# Los Alamos National Laboratory

Date: **October 2, 1995**  
Refer to: **EM/ER:95-472**

**SUBJECT: MODIFICATION TO THE RESOURCE CONSERVATION AND RECOVERY ACT FACILITY INVESTIGATION (RFI) WORK PLAN FOR OPERABLE UNIT (OU) 1147, LOS ALAMOS NATIONAL LABORATORY NM0890010515**

Enclosure: Material Disposal Area C Drilling Locations

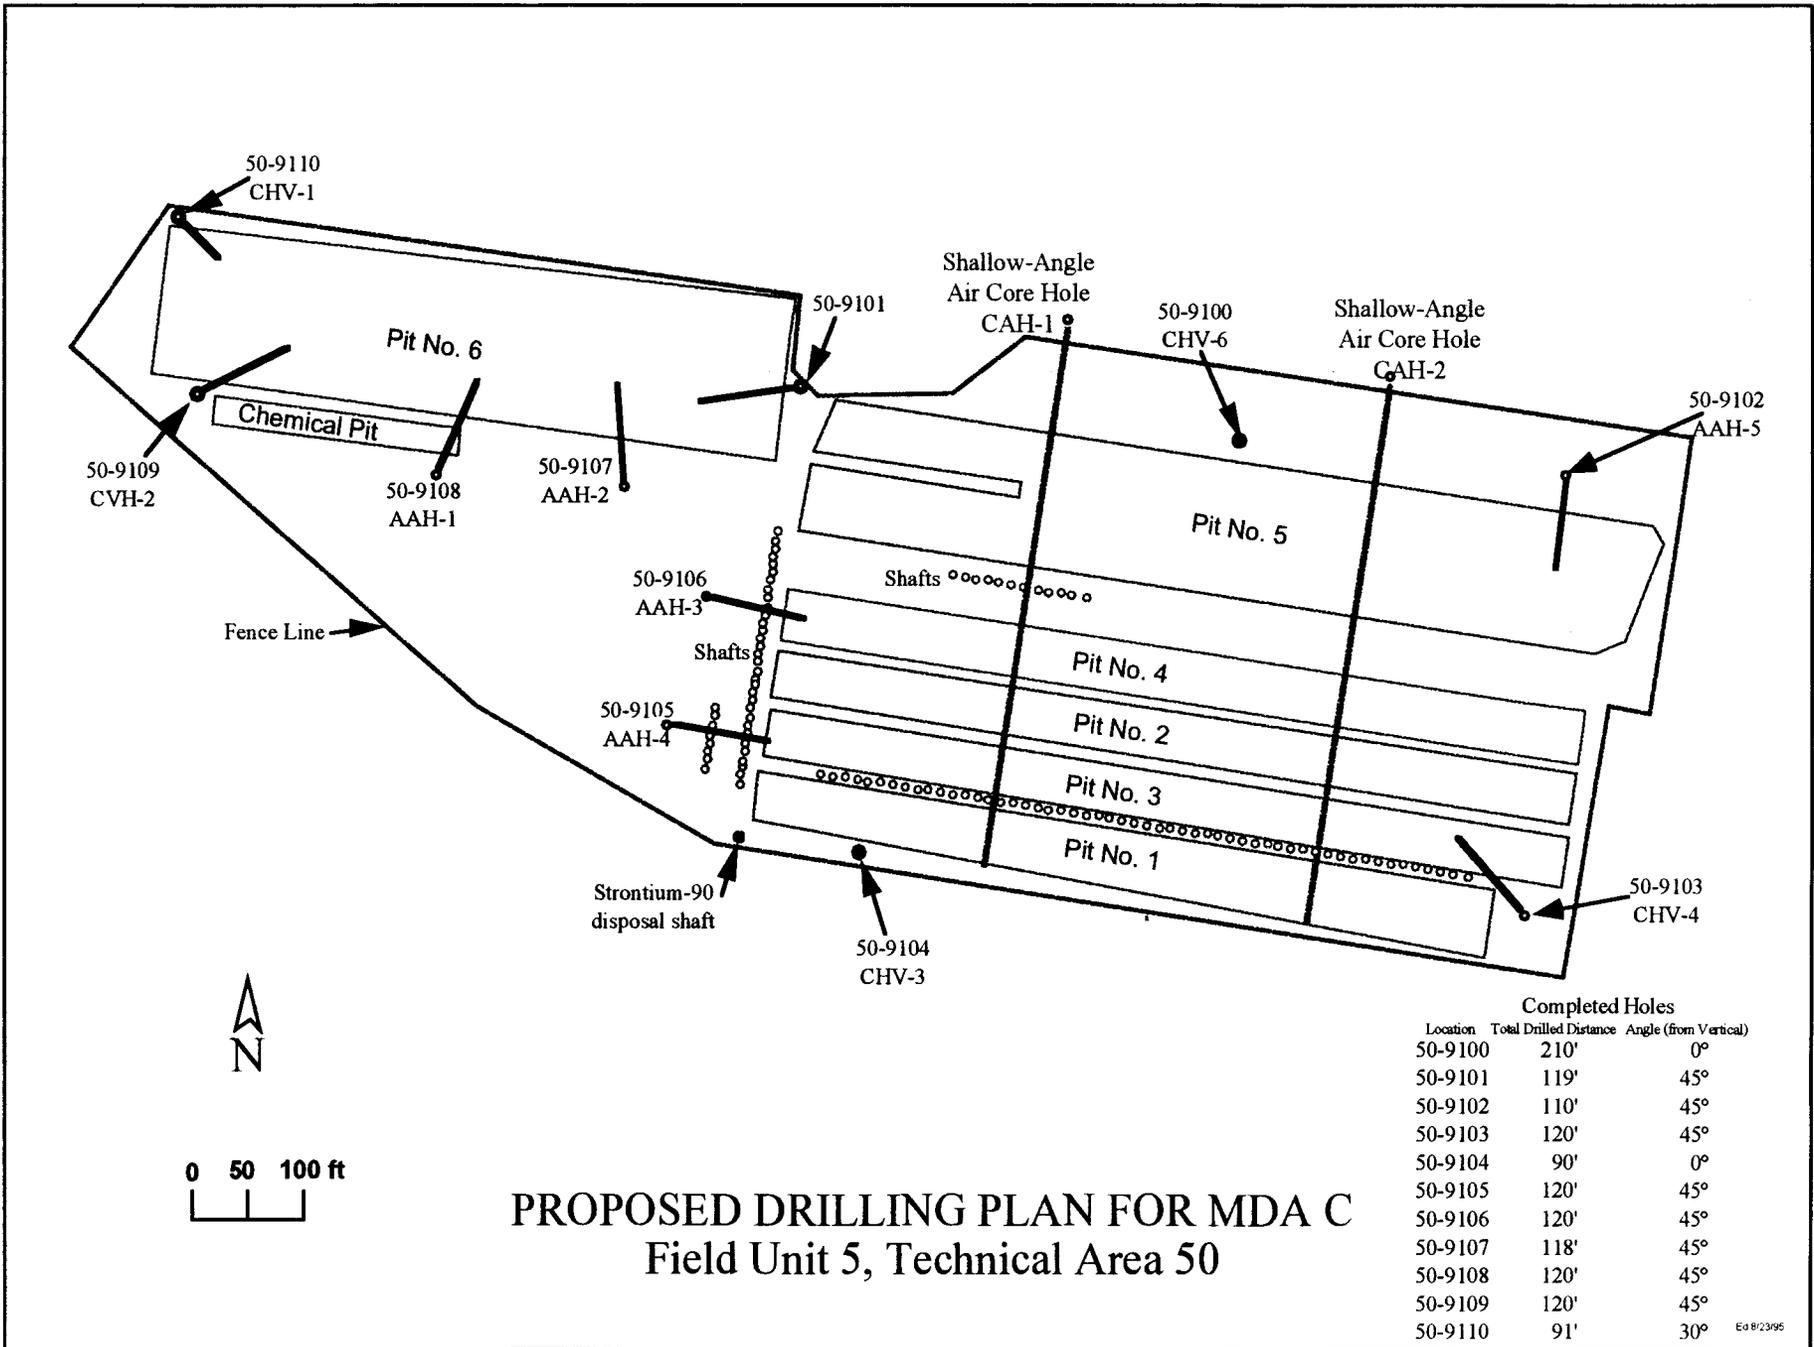
Stage 1. Angled and vertical holes will be air cored. Geophysical measurements made recently for field placement of the holes have shown that Pits No. 1-5 extend farther to the east than indicated on drawings, and a utility corridor exists immediately to the east of the pits. Pit 1 extends farther to the south and the boundary is slightly angled so that the available space between the pit and fence (and adjacent utility corridor outside the fence) tapers from approximately 9 feet on the west end to a negligible distance on the east end. In addition, Pit No. 6 extends further to the north than shown on the drawings, allowing less clearance than previously expected from the acid drain lines between Technical Area (TA) -55 and TA-50. Because of these

findings, the placement and angles of some of the holes have changed from the drawing we sent you previously. The enclosed drawing shows our current proposal, which, we believe, addresses the same issues as the earlier proposal.

The purpose of stage 1 is to bound contamination. Where possible, holes will be angled toward the adjacent pit, so that data on moisture below the pit can be obtained. This information can be used to evaluate the possibility of water collecting in the pits from rainfall or snowmelt and serving as a driving force beneath the pit. Data on moisture would also bear on transport potential and offer information on possible remediation or stabilization mechanisms.

Pit No. 6 extends to the fence on the north side and possibly beyond the fence towards the east end of the pit. We, therefore, cannot drill any holes on the north side of the pit. In addition, acid waste lines extend along the north side of Pit 6 from TA-55 to the treatment facility. Additional coreholes including shallow-angle holes, may be placed during a later stage of investigation if the findings from the first stage indicate that they are necessary. In keeping with the philosophy of bounding the contamination, as well as not being able to drill due to lack of space, we propose to omit the vertical coreholes on the north side of the Chemical Pit proposed by the Environmental Protection Agency.

The angled holes will give information about the presence of contaminants at a range of depths below the trenches and to give information about the depths of the trenches themselves. We know from geophysical surveys that the horizontal dimensions of the trenches and locations of shafts available from historical drawings are not totally accurate; there is no reason to believe that the vertical dimensions on the drawings are more accurate. Further, in 1986, a cover of crushed tuff and soil was applied to MDA C. This cover is known to have had a variable thickness across the area, and we do not have records of the thickness at any given point. The inaccuracy in our knowledge of the depths of the trenches and shafts may be as much as 30 feet. For safety reasons, we must ensure that drilling will not intercept disposal trenches and shafts.

Drilling began on July 17, 1995. Vertical hole 50-9100 has been completed to 210-foot depth, and 45°-angled hole; 50-9102 has been completed to 110 feet total length. Angled hole 50-9106 has been completed at 45° to a total length of 120 feet. Vertical hole 50-9104 has been completed to 90 feet deep. This hole was not angled due to restricted access. Hole 50-9103 has been drilled to 120 feet at an angle of 45°, but has been moved northwest of the previously indicated position (to angle under the end of Pit 3) because of geophysical findings. The 210-foot depth of 50-9100 will

Another change we have made to improve containment of dust and cuttings, is the use of a specially modified air drill rig in place of an auger rig for the near-vertical and 45 holes. This is an improvement to the plan presented on July 7.

Completed Holes		
Location	Total Drilled Distance	Angle (from Vertical)
50-9100	210'	0°
50-9101	119'	45°
50-9102	110'	45°
50-9103	120'	45°
50-9104	90'	0°
50-9105	120'	45°
50-9106	120'	45°
50-9107	118'	45°
50-9108	120'	45°
50-9109	120'	45°
50-9110	91'	30°
